Service Bulletin No. 017AT.7.66.002A

## Engine firewall installation

**1. Subject:** Installation engine firewall.

**Type:** LAK-17AT

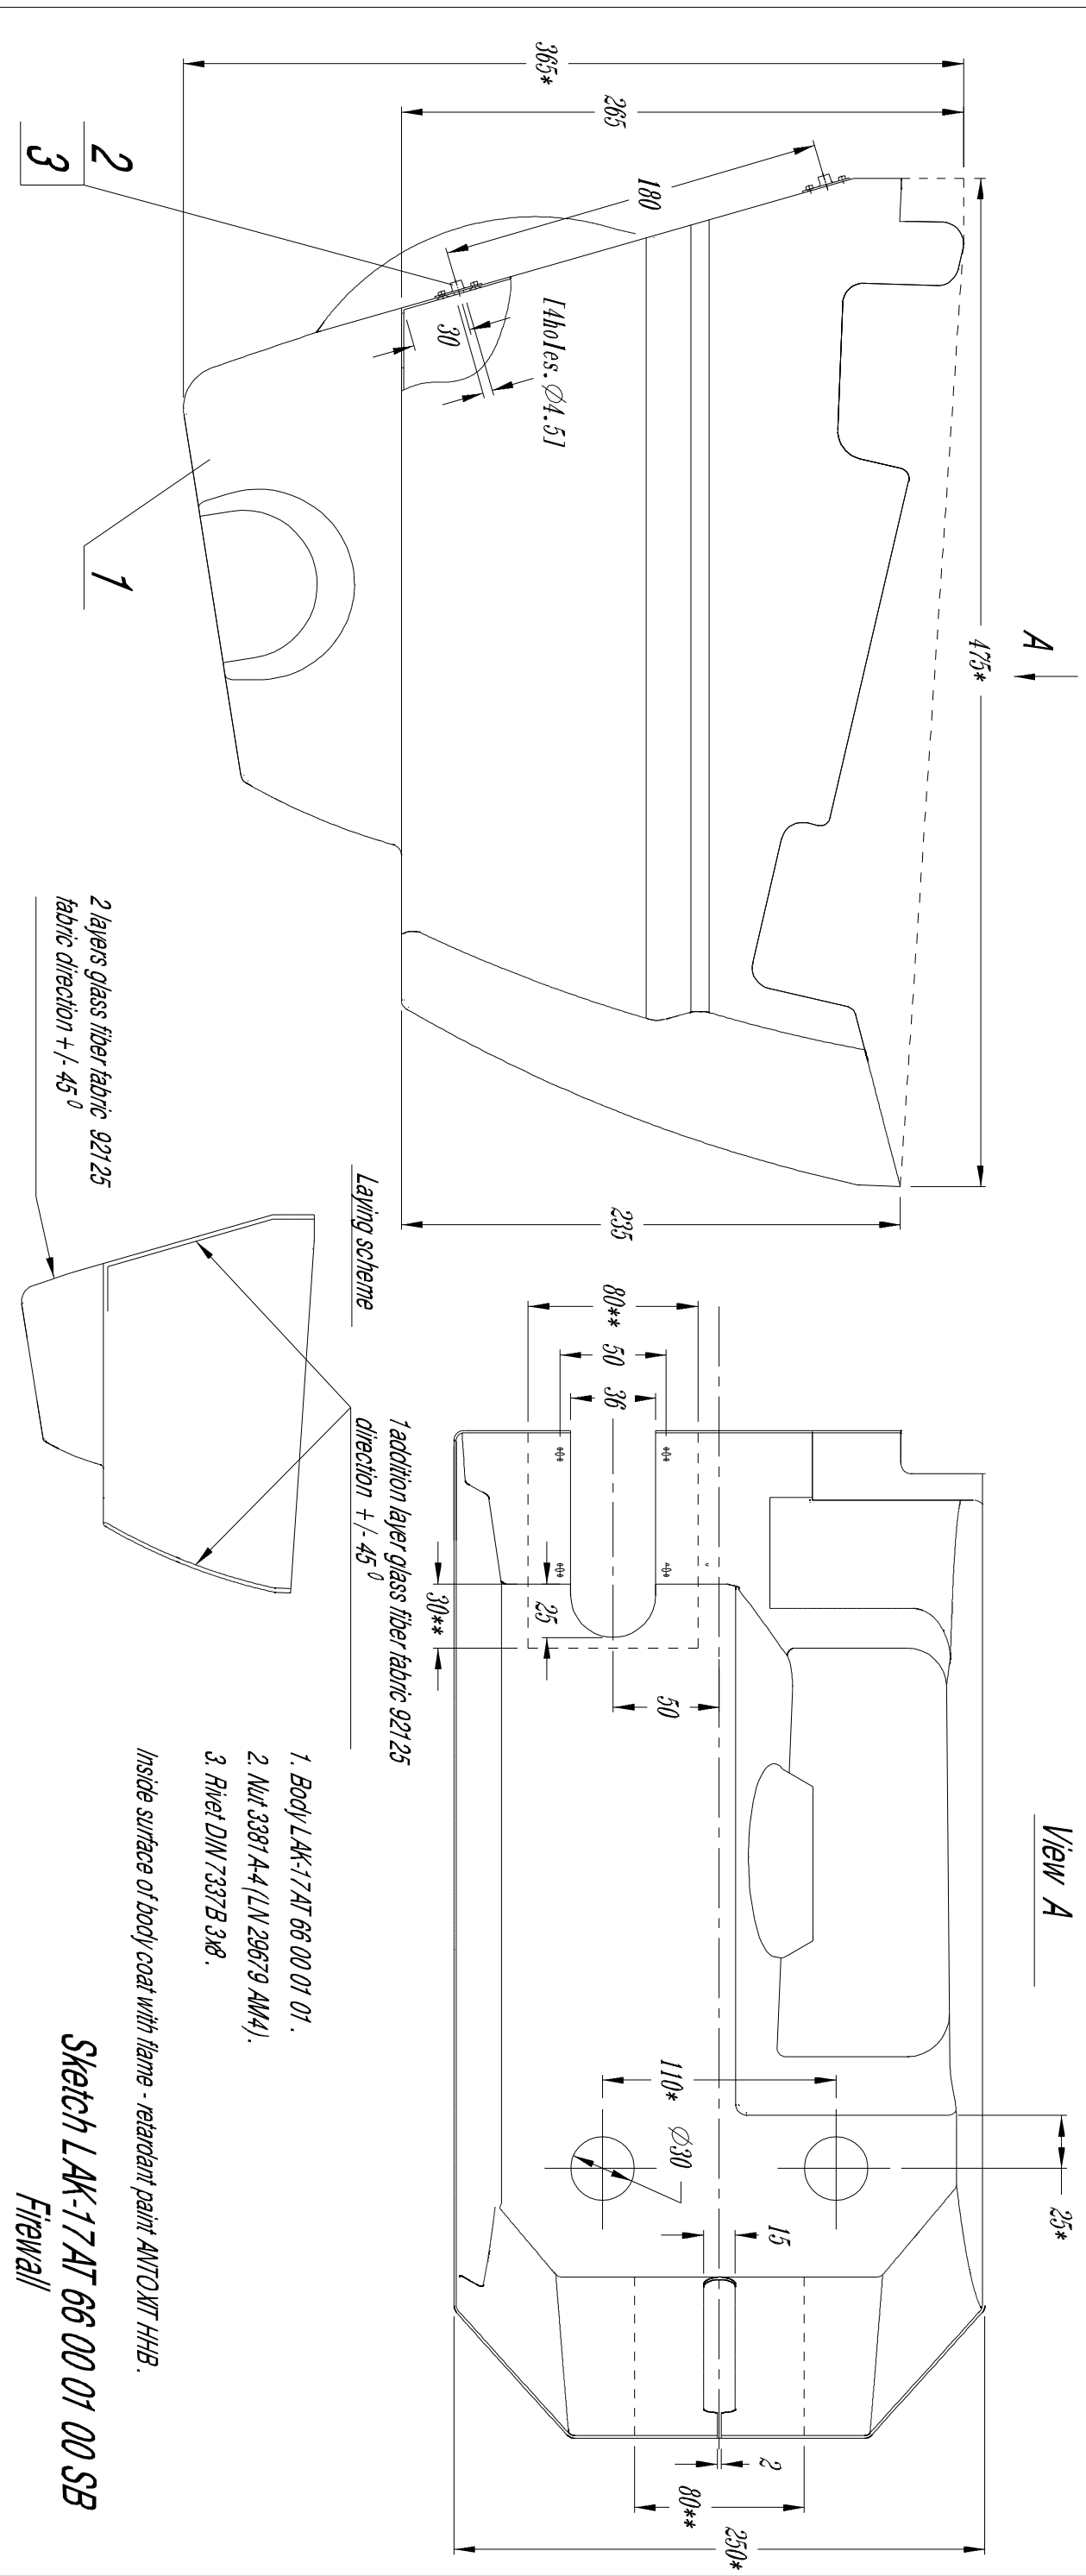
5.3 to mount engine firewall to its appropriate place (see Sketch LAK-17AT 66 00 01 00 SB);

5.4 after regulations and correctness position firewall, cut edge top contour. Inspect minimal distance between control rods (see Sketch LAK-17AT 66 00 00 00 SB);

5.5 mark points on the firewall for attachment and drill the holes  $\varnothing 3$  mm (see Sketch LAK-17AT 66 00 00 00 SB);

- 5.6 according firewall holes drill holes  $\varnothing 3$  mm in the arms of attachment;
- 5.7 inspect place for detail LAK-17AT 66 00 00 01 and drill 4 holes  $\varnothing 4,5$  mm in the firewall for fastening nuts LN 29679 AM4 (see Sketch LAK-17AT 66 00 01 00 SB). Inspect minimal distance between rod control sistem of rudder (see Sketch LAK-17AT 66 00 00 00 SB);

- 5.11 to install engine firewall (see Sketch LAK-17AT 66 00 00 00 SB);
- 5.12 inspect minimal distances between rods control system from outside part of engine firewall and between engine from inside part;

*Sketch LAK-17AT 66 00 00 01*  
*Cover*

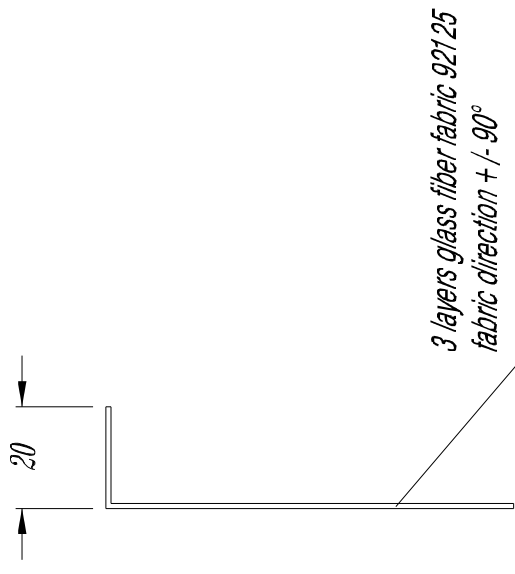
5.1 to mount in the engine bay details: LAK-17AT 66 00 00 01, LAK-17AT 66 00 00 02, LAK-17AT 66 00 00 03, LAK-17AT 66 00 00 04, LAK-17AT 66 00 00 05, LAK-17AT 66 00 00 05-01, (see Sketch LAK-17AT 66 00 00 00 SB, LAK-17AT 66 00 00 01, LAK-17AT 66 00 00 02, LAK-17AT 66 00 00 03, LAK-17AT 66 00 00 04, LAK-17AT 66 00 00 05, LAK-17AT 66 00 00 05-01);
